VALUE ENGINEERING CONSTRUCTABILITY STUDY
OF
I-64 MAJOR WIDENING
from EAST of VAN METER ROAD to EAST of the
MOUNTAIN PARKWAY

ITEM NUMBER: 7-33.00

Clark County, Kentucky

Prepared by:
VE GROUP, L.L.C.

AS PROPOSED LOCATION OF 16' x 3' RCBC UNDER RJ CORMAN RR BRIDGE

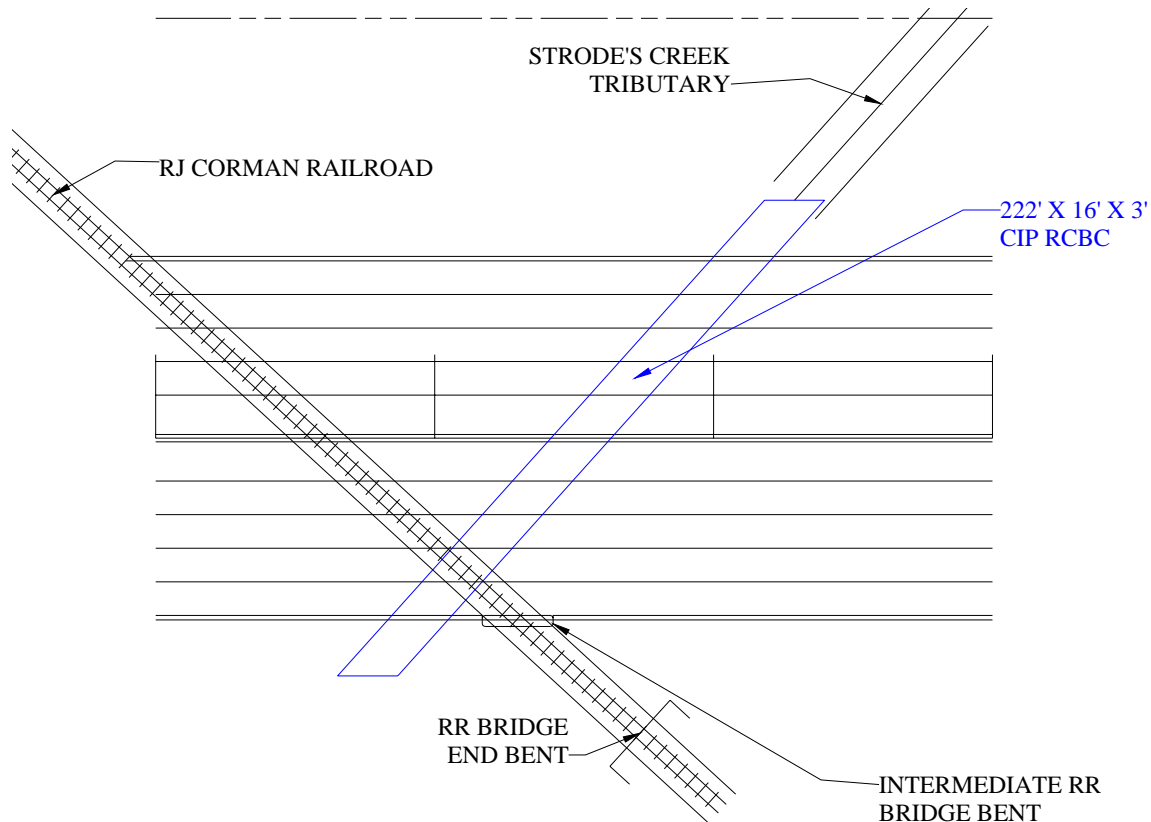
The current design calls for the replacement of a 12' x 4' Reinforce Concrete Box Culvert (RCBC) at Station 1315+50 with a 222' x 16' x 3' cast-in-place RCBC in the same location. The lowering of the profile grade in this location to provide the necessary vertical clearance under the RJ Corman Railroad (RR) Bridge requires the new culvert to have a reduced height of 3' and to maintain the existing cross sectional area the width is increased from 12' to 16'. The culvert is on a +/- 45° skew. The construction of the new culvert will require maintaining sporadic storm water flows from the south to the north of I-64.

The assumed sequencing of the construction will be removal and replacement of the median section, shifting traffic to the median and removal and replacement to outside. During the construction the storm water capacity of the existing and new culvert will be reduced because of temporary construction joints. The culvert under the eastbound roadway is also under the RJ Corman Railroad Bridge. The construction of the 16' x 3' culvert under the railroad bridge will require special attention in order to avoid the railroad structure.

The Value Engineering Team recommends constructing the 16' x 3' RCBC perpendicular to the centerline of construction at approximately Station 1316+20 using precast sections. The storm water will be conveyed to the new box culvert via a ditch with a 10' bottom and class II Channel lining. This will shorten the culvert to approximately 150 LF. The paved ditch will be approximately 200' long with 1.5:1 and 1.2:1 side slopes.

The two major advantages of constructing the culvert on a new location are: 1) the existing culvert will maintain any storm water flows that may occur without any additional work and 2) when the new culvert is operational the existing culvert will not have to be torn out since it can be back filled with Safe loading.

SOUTH SPAN OF RJ CORMAN RR BRIDGE STA 1315+50 (+/-)

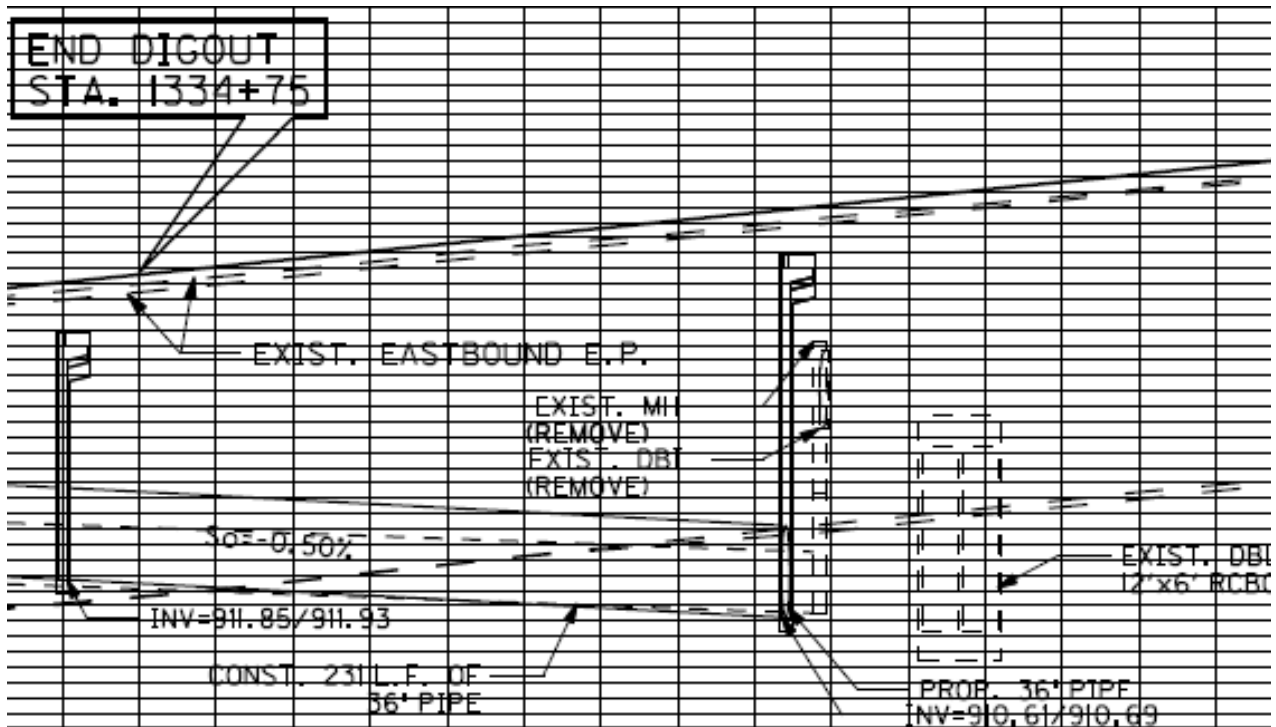
The paved ditch would be constructed under the south span of the RR Bridge and continue to the headwall of the headwall of the new location of the precast culvert. The outfall of the culvert will be in approximately the same location as the existing/proposed.

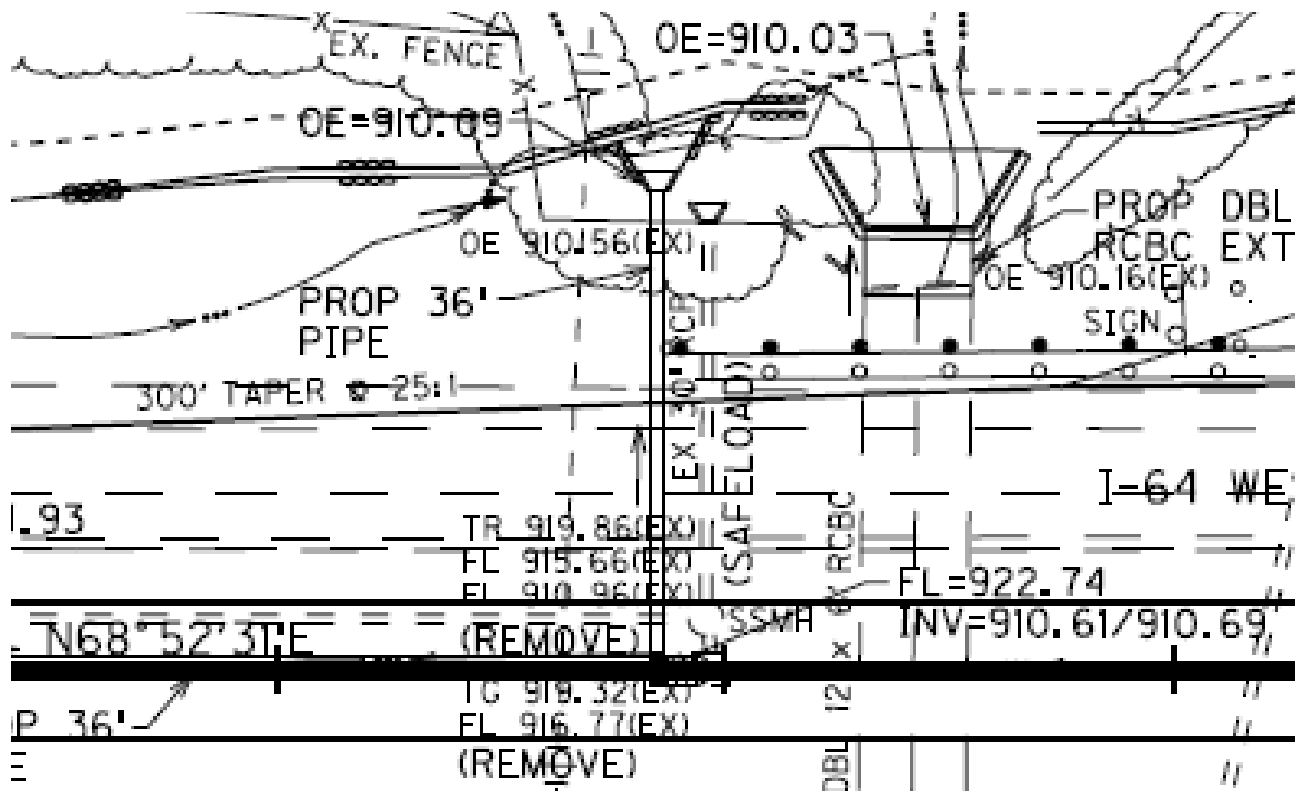
The outfall for the median drainage system between STA1326+00 and STA 1337+00 is located at STA 1336+90. It is 104 LF of 30" pipe that is perpendicular to the centerline and outfalls on the north side of the roadway. The end treatment is a cast in place concrete headwall.

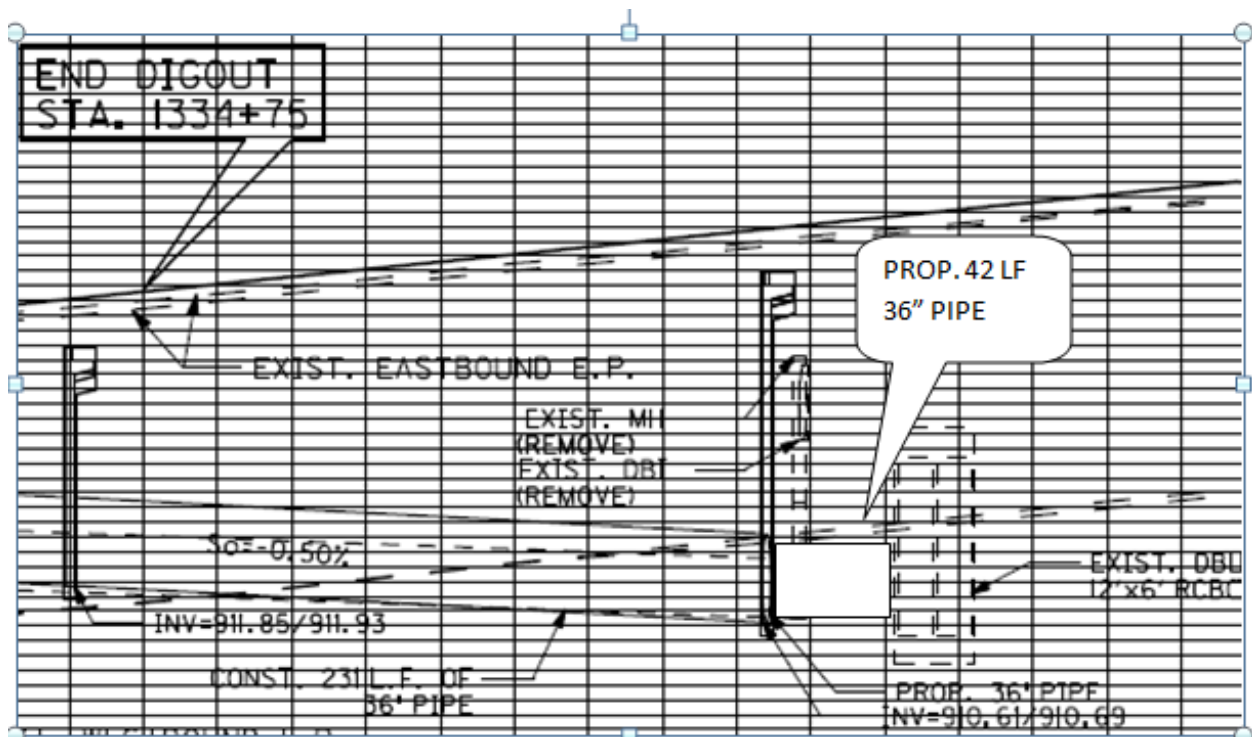
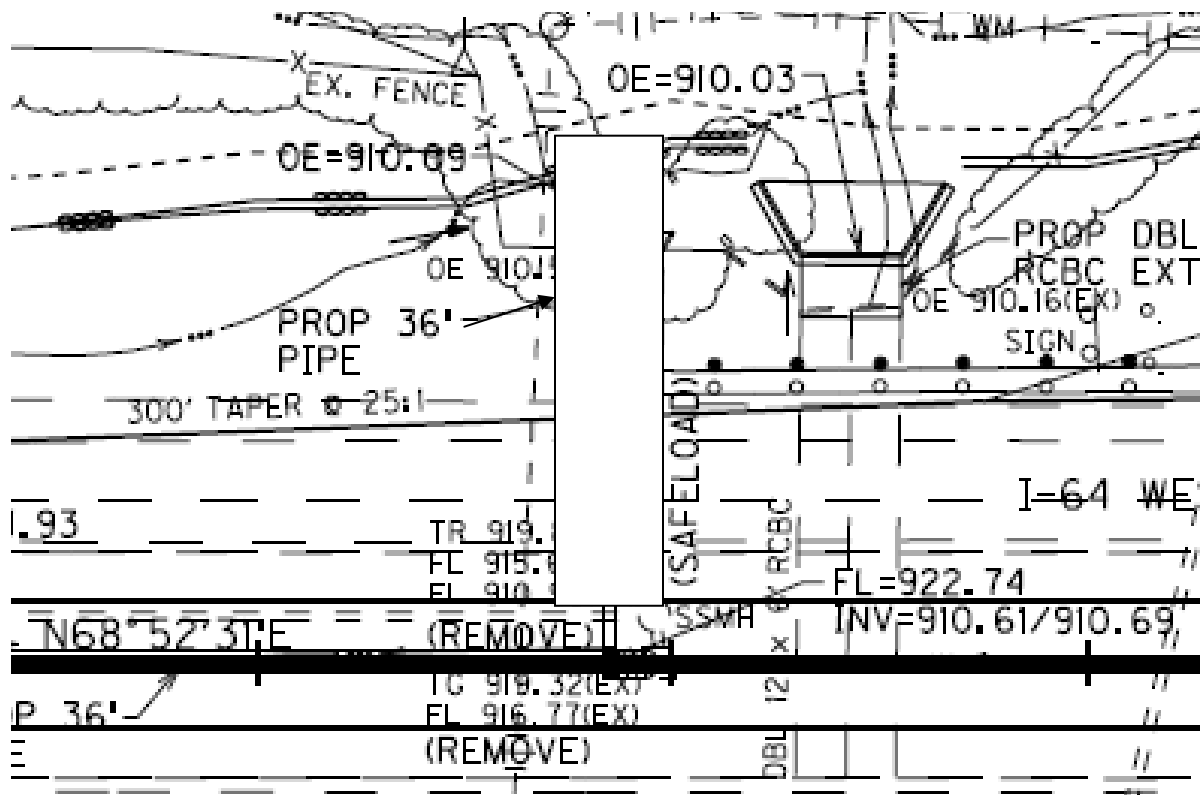
The Value Engineering Team recommends cutting into the double 12' x 6' RCBC and tie in the median drainage to the box culvert that is only +/- 42' from the junction box.

The two major constructability aspects of this are: 1) all the construction can be done in the median and 2) the interstate would not have to be dug out for the pipe which would lessen the impact to motorists.

GAP IN SIGN TRUSS SUPPORT

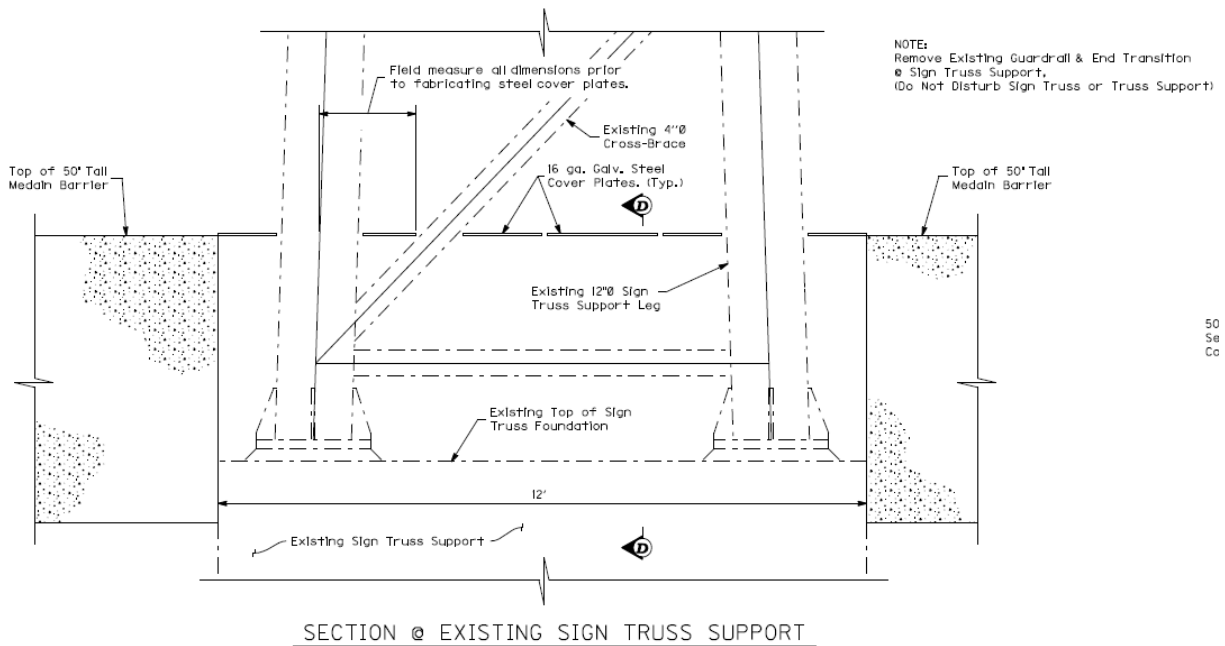
The foundation for the westbound ITS sign at STA 1400+00 will require a special design to tie in with the proposed median barrier. The median vertical support foundation is too low and will create a gap in the barrier system.

The As Proposed design will place approximately 50' of Tall Wall Transition Barriers on both sides of the existing foundation, creating a sump that will collect trash and water. To reduce the trash collection, 16 ga. galvanized steel sheets are placed over the sump and weep holes through the new barrier provide drainage.

In addition to correcting the median foundation, it was pointed out to the Value Engineering Team the need to maintain access to the maintenance ladder during and after construction.

VALUE ENGINEERING ALTERNATIVE MODIFIED SIGN TRUSS FOUNDATION

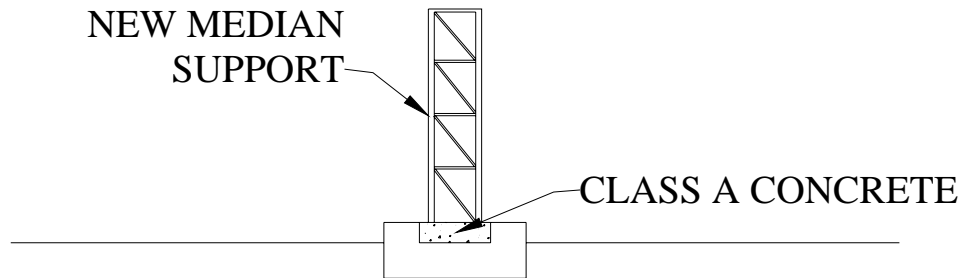
The Value Engineering Team recommends filling the gap between the Concrete Median Barriers type 12C (50) with concrete to eliminate the void and the possibility of collecting trash, dirt and moisture.

In order to accomplish this, the median support will be removed and replaced with a shorter support. Temporary support of the sign truss will be used to maintain operation of the ITS Sign.

This Value Engineering Alternative will eliminate the possibility of dirt, water or trash collecting in the void between the concrete barriers placed along the foundation.

There should also be a note in the plans to ensure access to the maintenance ladder during and after construction.

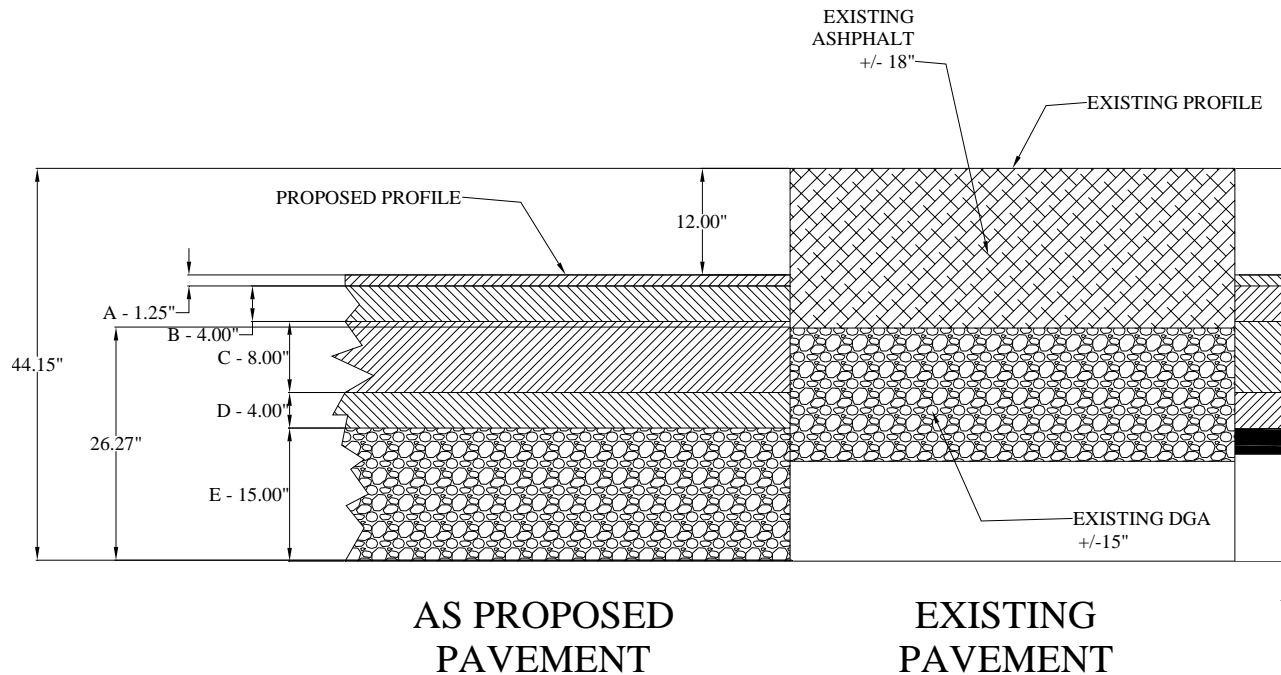
The existing pavement will be removed and the sub-grade will be removed to provide the necessary vertical clearance under the two railroad overpasses.

The pavement will be replaced with the pavement section as shown below. This work begins at STA 1306+00 and ends at STA 1334+75.

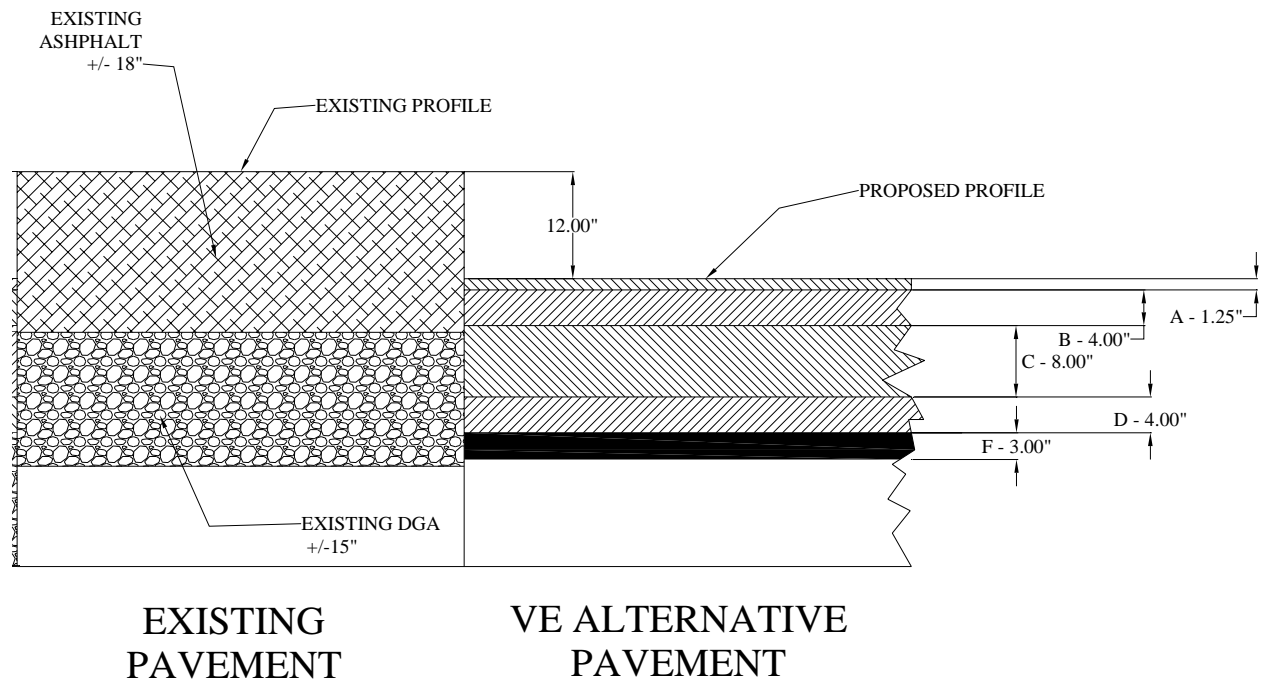
The Value Engineering Team recommends replacing the 15' DGA with a 3" black base layer.

This alternative will reduce the amount of earthwork and will be quicker construction.

AS PROPOSED
PLAN VIEW

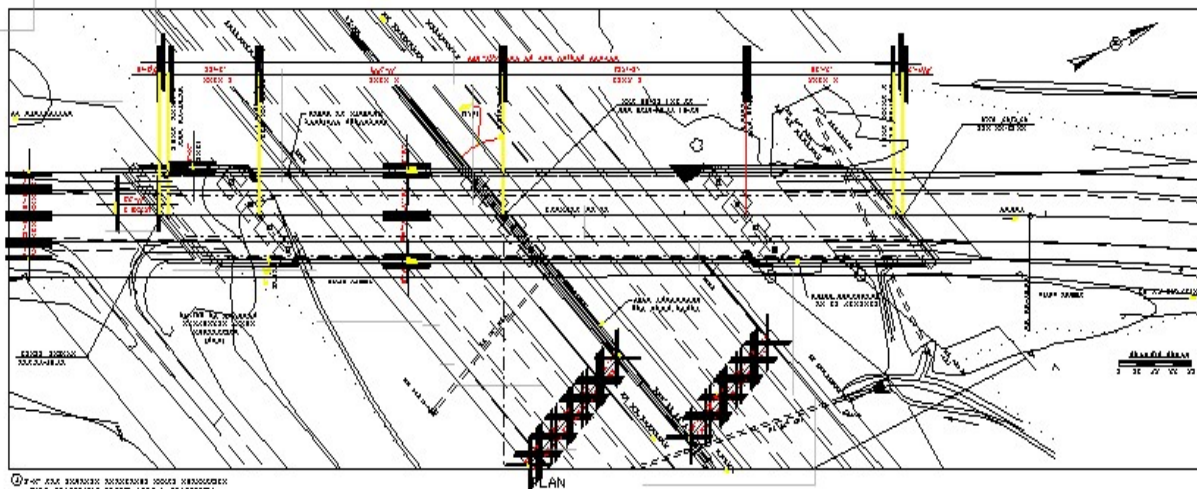
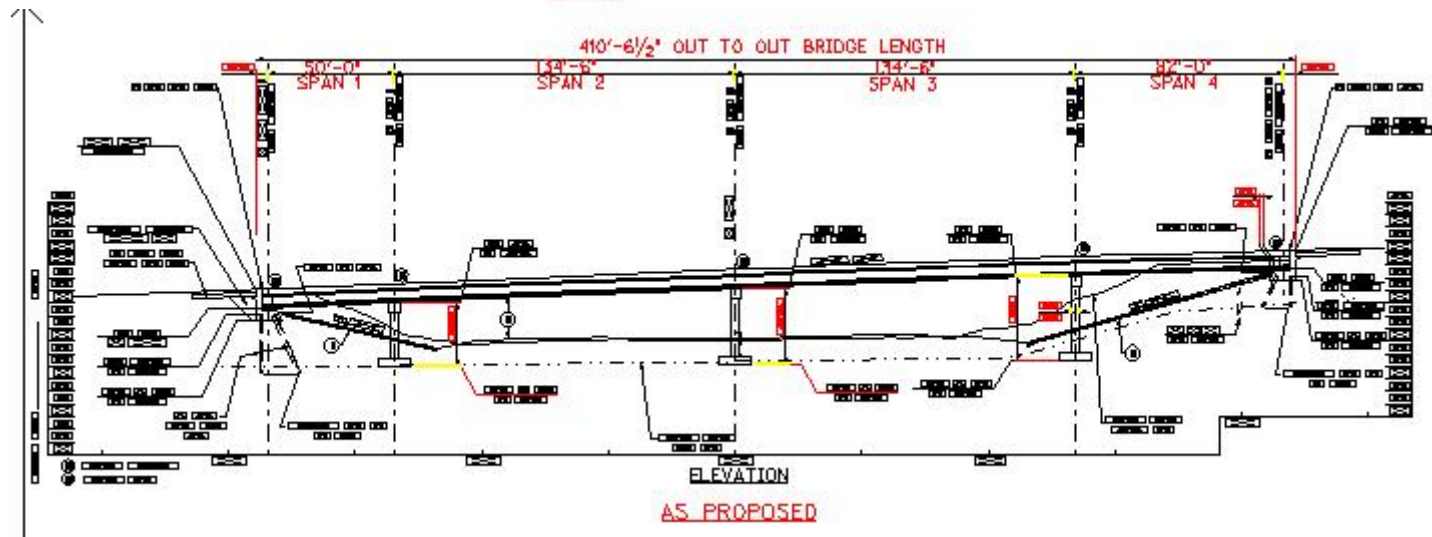
The As Proposed structure is a four span (50'-0", 134'-6", 134'-6", 82'-0"), Type 6 (66" deep) Precast I-Beam (PCIB) bridge with piers on spread footings and pile end bents, 43'-0" out to out width, on a 45° Left skew.

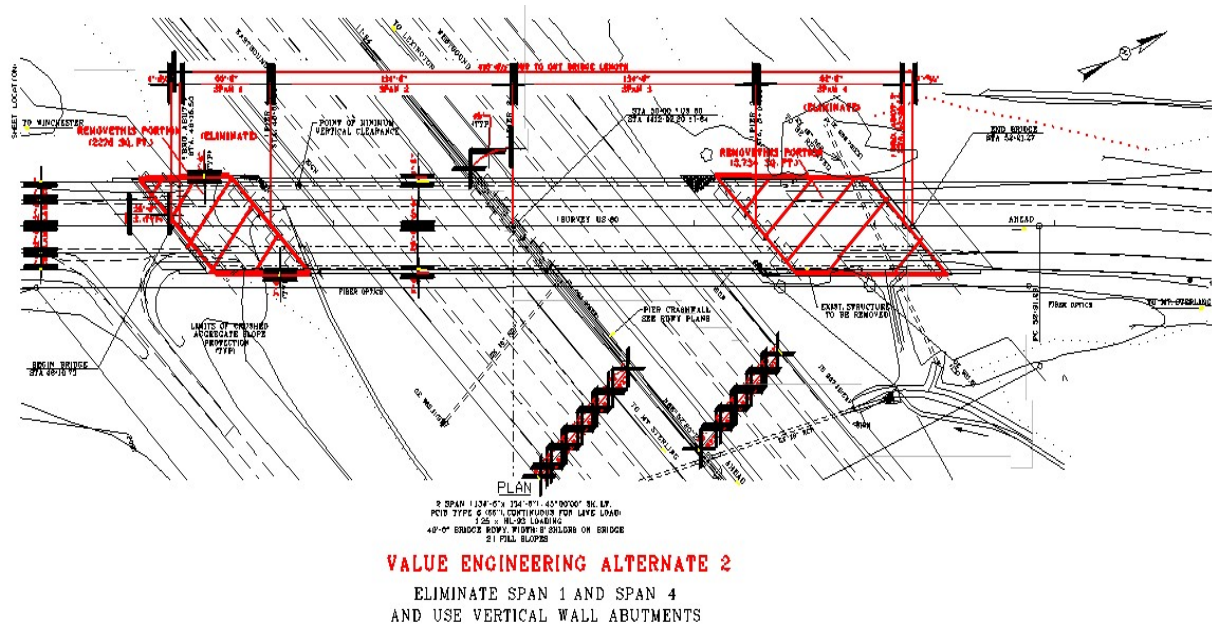
The value engineering alternative consists of eliminating the end spans, span 1 (50'-0") and span 4 (82'-0"). The alternative would use MSE walls with a vertical abutment that would follow the side slopes.

This would eliminate 132 LF of bridge and approximately 6,010 square feet of deck area.
